Product Change Notification / LIAL-09VUUA424

CCB 5151 Final Notice: Qualification of a new lead frame DAP surface prep material for selected KSZ8041xx, SPNZ80105xx and KSZ8851xx device families available in 32L VQFN (5x5x0.9mm) package assembled at MTAI assembly site.

CCB#: 5151
Pre and Post Change Summary
PCN #: LIAL-09VUUA424

Pre Change

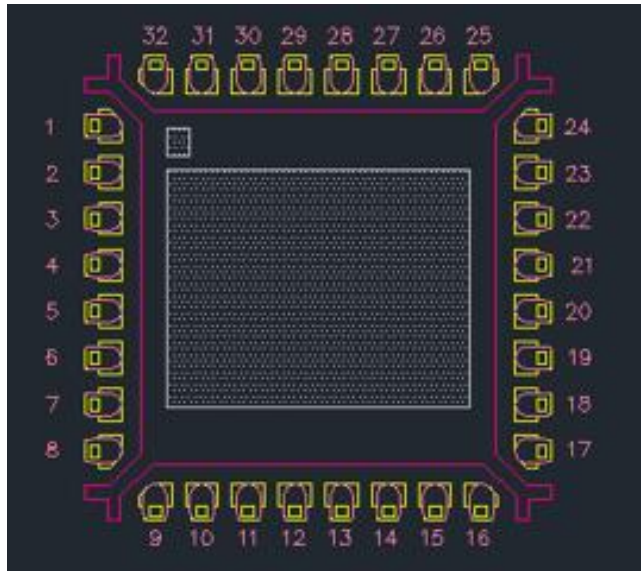
Lead frame DAP surface prep

Ag selective plating

Post Change

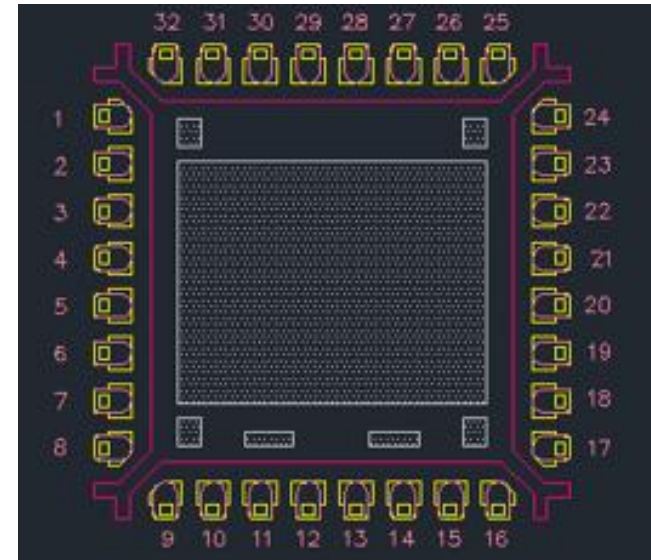
Lead frame DAP surface prep

Ag selective plating (Add more Ag area)
